CITY OF GOODLETTSVILLE PLANNING COMMISSION

CITY OF GOODLETTSVILLE PLANNING COMMISSION

STAFF AGENDA REPORT

Monday May 6, 2024 5:00 PM

PRELIMINARY MASTER PLAN

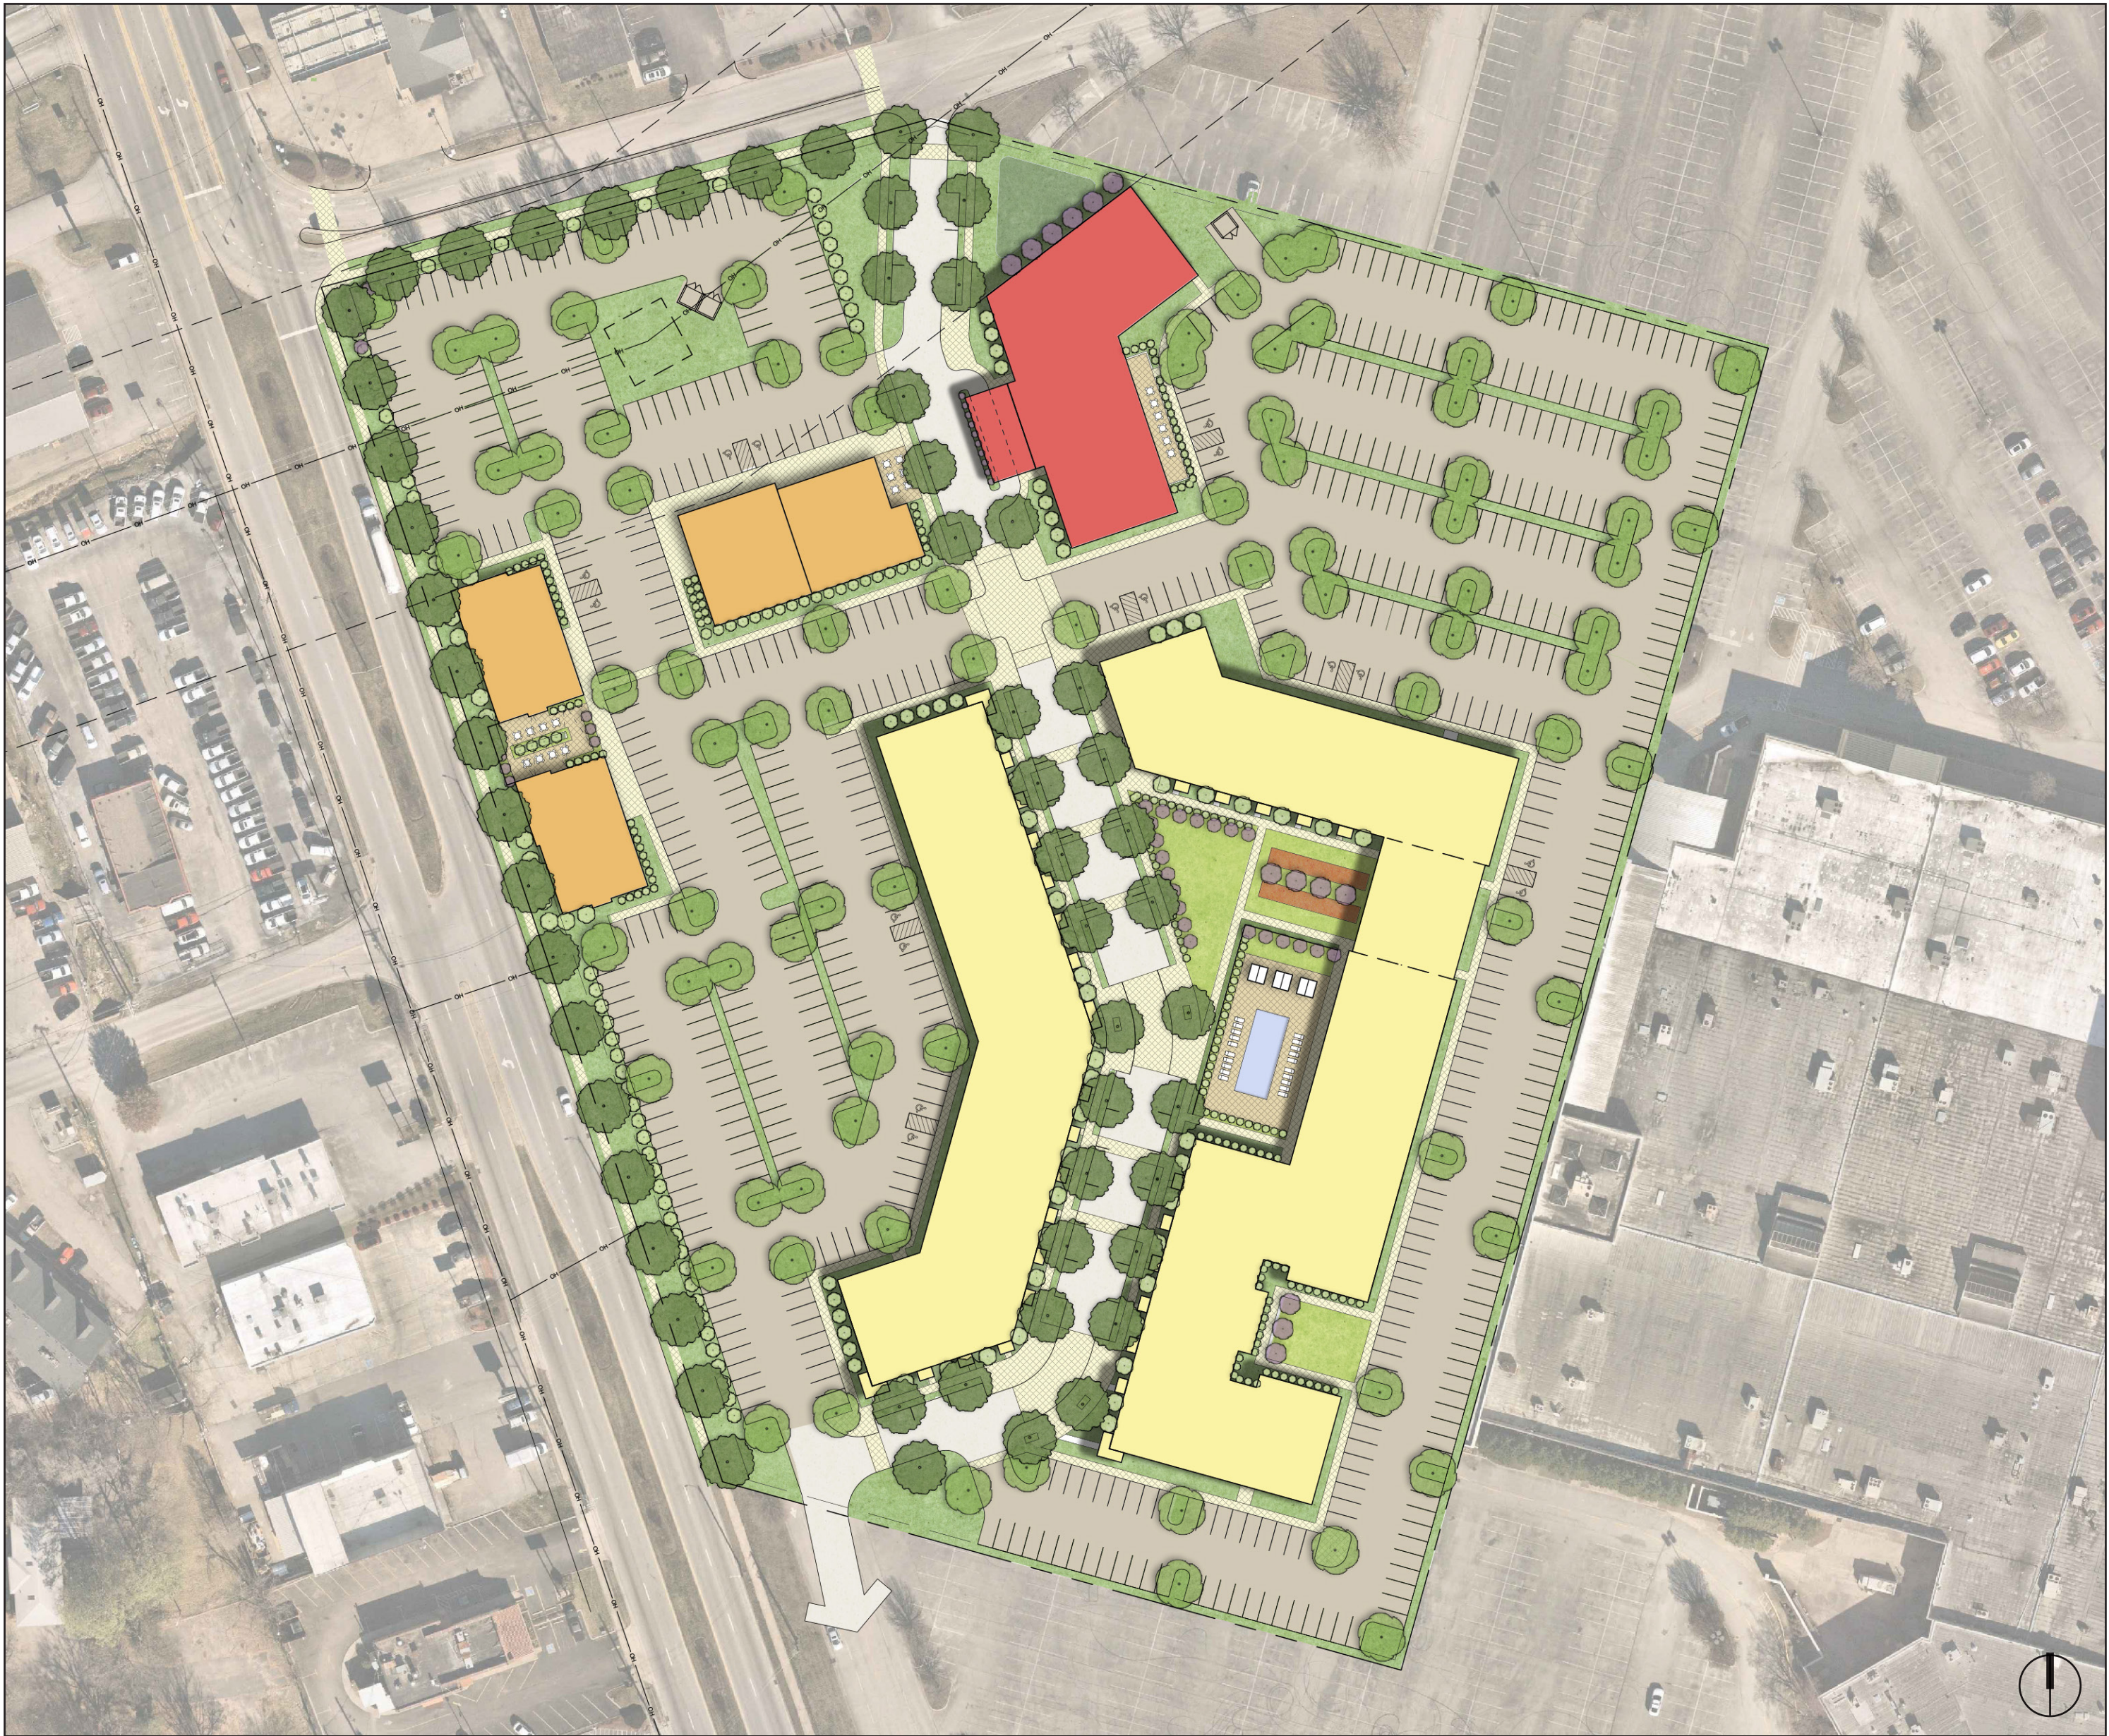
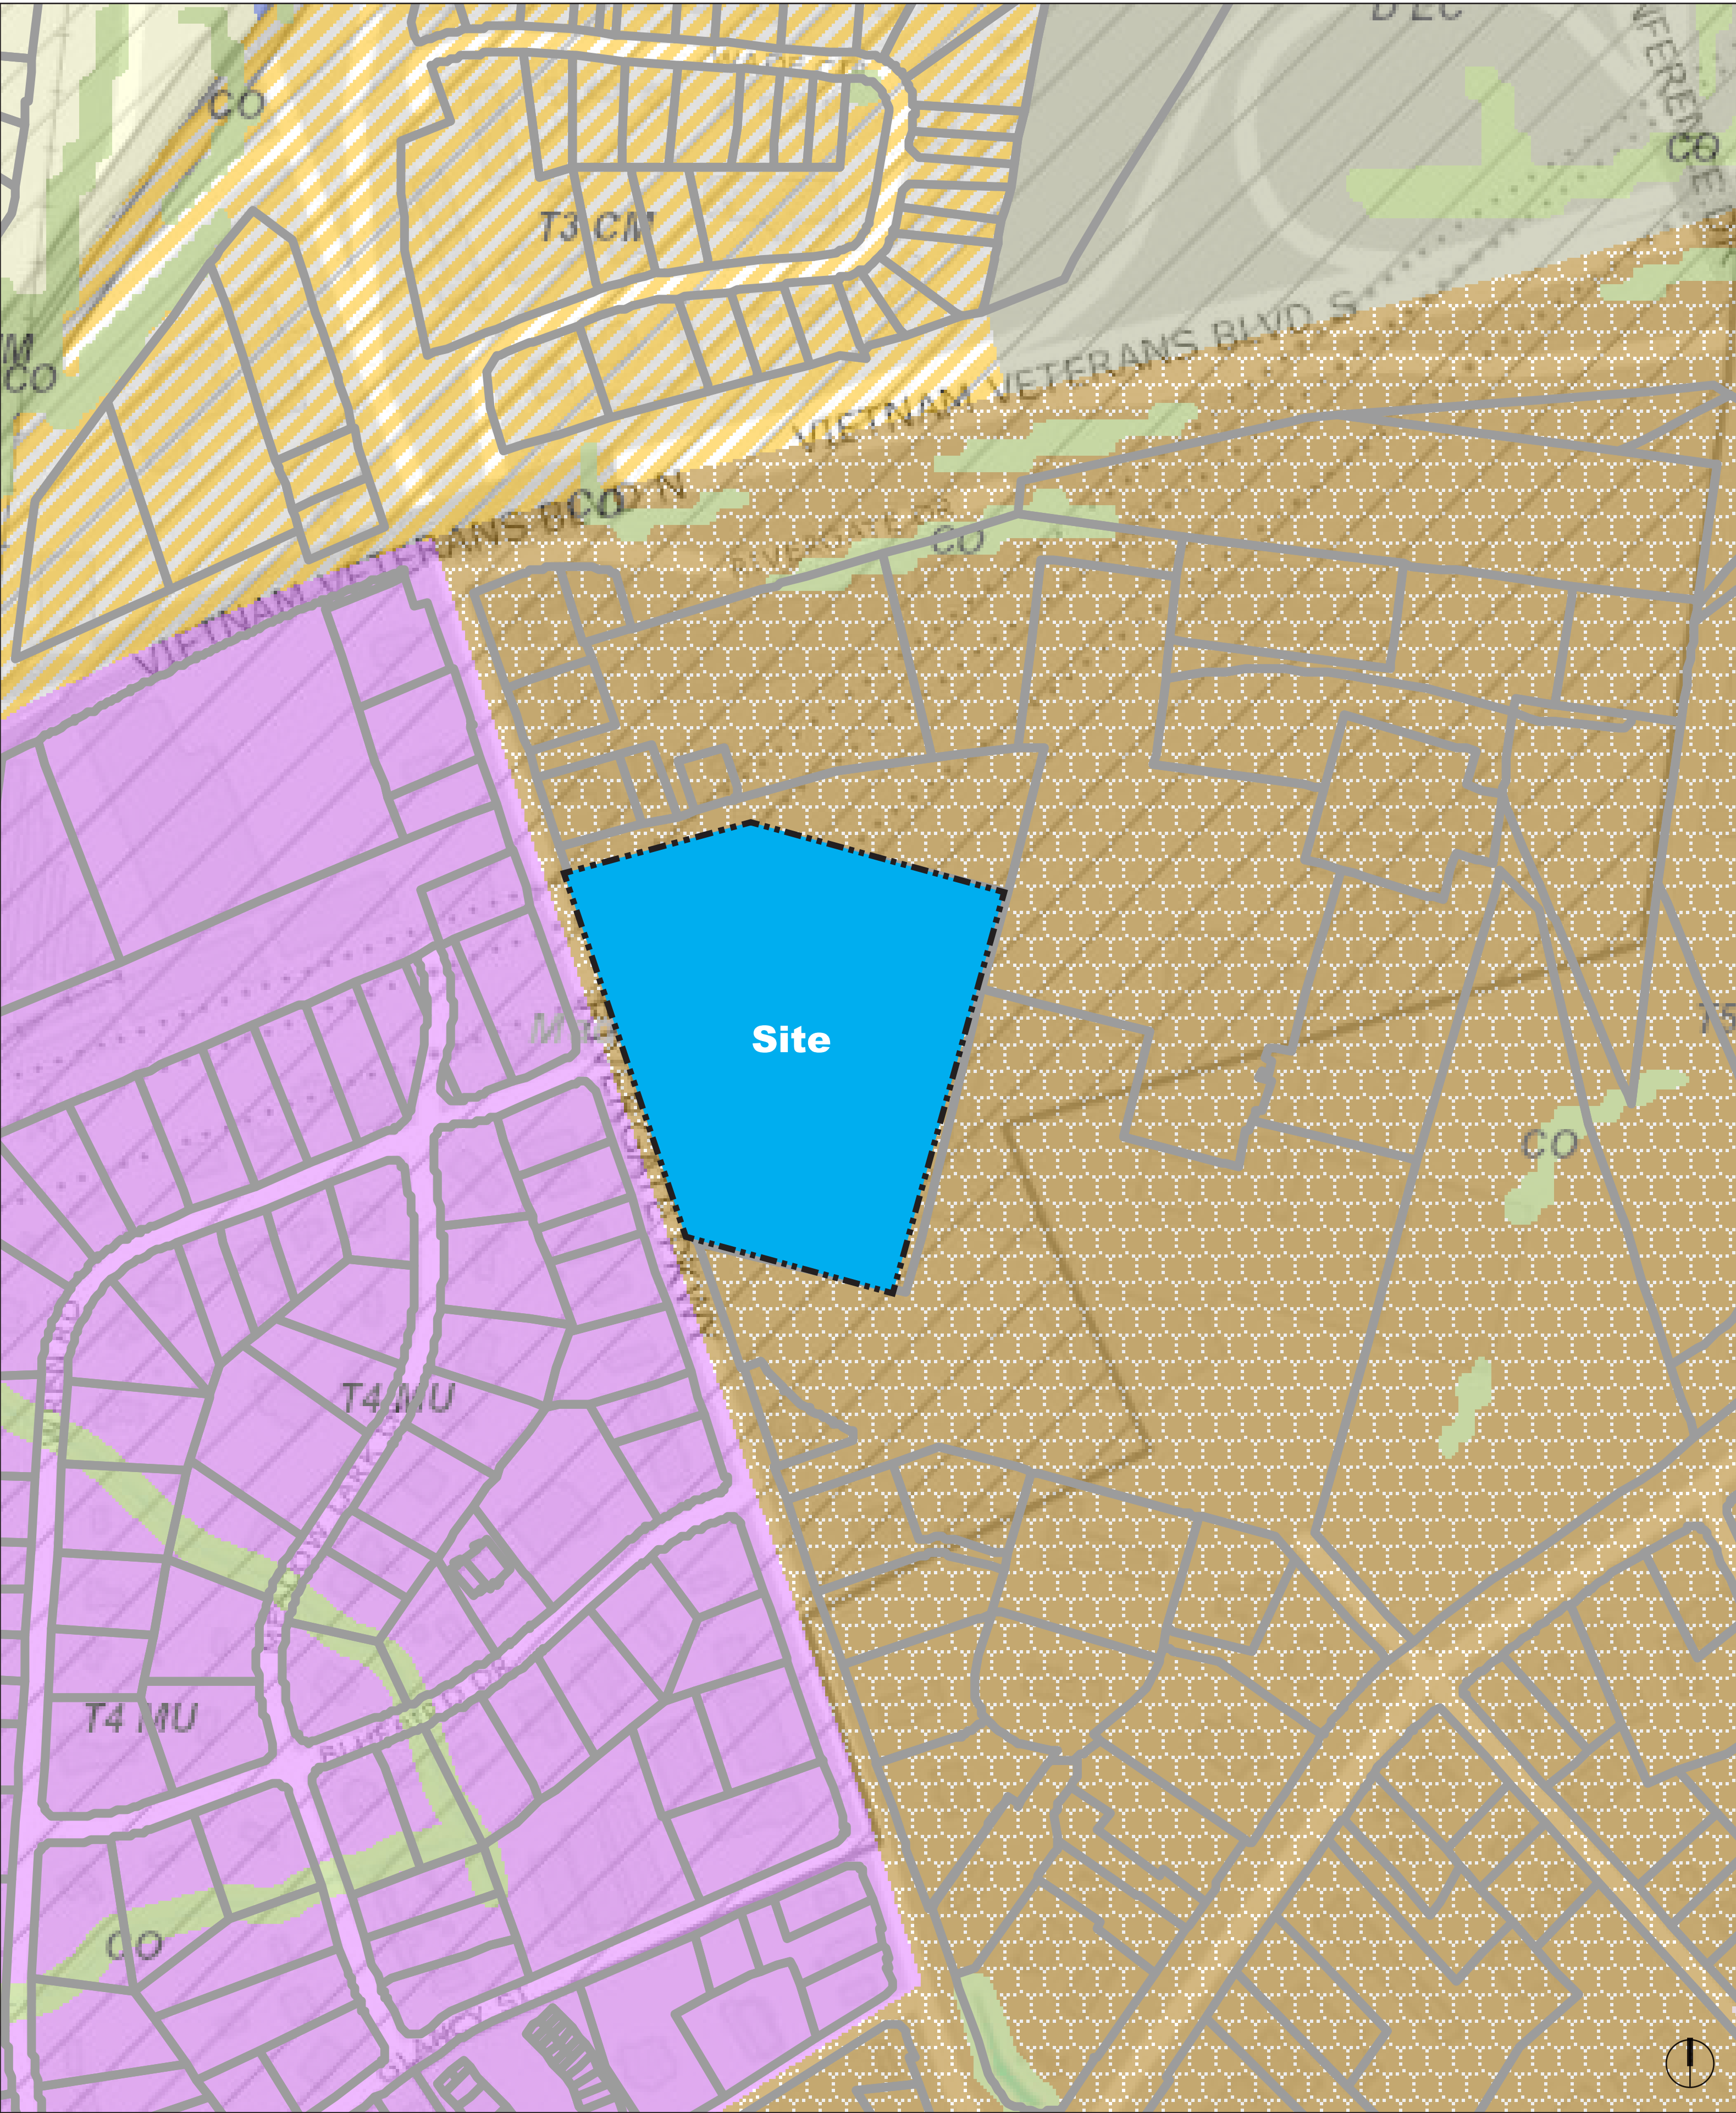
The project includes the demolition of the former Macy's building that is connected to the RiverGate mall building. See the applicant's response to staff plan review comment about the existing mall building connection.

Provide information on proposed/concept exterior design of mall area with building demolition. Existing Macy's Building to be demolished. Existing cmu block demising wall to mall concourse to remain and be stabilized. Infill wall openings with cmu block and repaint the entire wall with a neutral color. Proposed mall building improvements seem appropriate given that Rivergate Mall property is currently listed for sale and the site is a viable location for redevelopment.

The preliminary master plan includes renderings of the proposed buildings. The project designs will be required to meet the City's Design Guidelines. The one level commercial projects will need to be designed to have the appearance of larger height two (2) story buildings to meet the streetscape design intended with Regional Center developments. The building designs could include different design options to for an increased height appearance with a one-story use.

The project proposal includes 340 residential units including 197- one bedroom and 143- two (2) bedroom units. The proposal is for 510 parking spaces/1.5 parking spaces per unit. The City's parking requirement would be 581 parking spaces based on the bedroom unit breakdown. The City has reviewed and approved similar reduced parking requirements for larger scale residential developments in a mixed use setting with preliminary master plan review process.

1. City Fire Marshal and Fire Department requests a twenty-six (26') feet width access drive provided from private Rivergate Parkway drive connection between the proposed hotel and commercial building connecting to the twenty-six (26') feet drive behind the proposed buildings adjacent to the existing mall building. Twenty-six (26') feet drive shown as solid red line on plan sheet page thirteen (#13).
2. All building designs including residential buildings, hotel, and commercial outbuildings to meet the City's Design Guidelines. If the preliminary master plan is approved, the building formal designs to be submitted with a final master plan process including materials and color requirements.
3. Commercial outbuildings to be designed to meet streetscape design increased building height similar to a two (2) story building. If the preliminary master plan is

- approved the commercial outbuilding designs to be submitted with the final master plan process including materials and color requirements and designs to be similar to the building height of two (2) story buildings.
4. Adjacent mall building and parking designs. If preliminary master plan is approved the design of the revised mall building exterior design and disconnected adjacent parking lot connections to be finalized including written letter from the adjacent property owners. The intention is for the usability of the adjacent mall building and adjacent parking spaces next to the disconnected project parking boundary.
 5. Rivergate Parkway traffic signal and turn lane review. If preliminary master plan is approved, provide with final master plan a traffic study to determine any traffic signal or turn lane alterations needed
